Seismic Provisions for Structural Steel Buildings (1997) Supplement No. 2

November 10, 2000

Supersedes Supplement No. 1 to the AISC *Seismic Provisions for
Structural Steel Buildings*, dated February 15, 1999

Prepared by the American Institute of Steel Construction, Inc.
under the direction of the AISC Committee on Specifications and
approved by the AISC Board of Directors

Fig. C-13.2. Brace-to-gusset plate requirement for buckling out-of-plane bracing system.

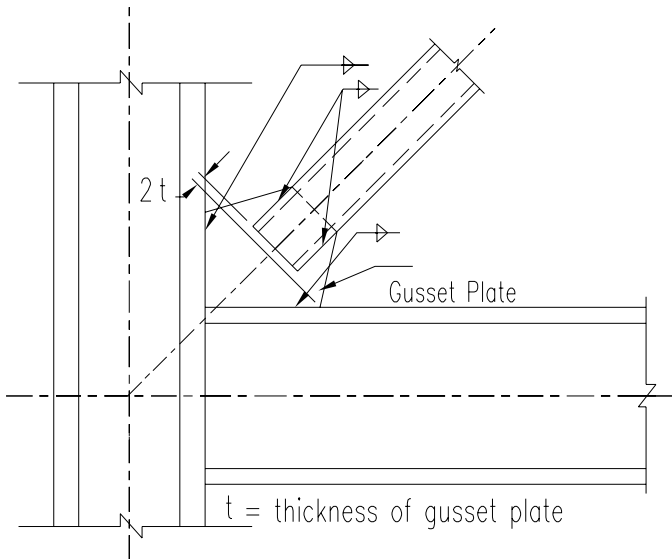
50. Commentary Part I, Figure C-13.2

Replace the existing Figure C-13.2 with the following Figure C-13.2.
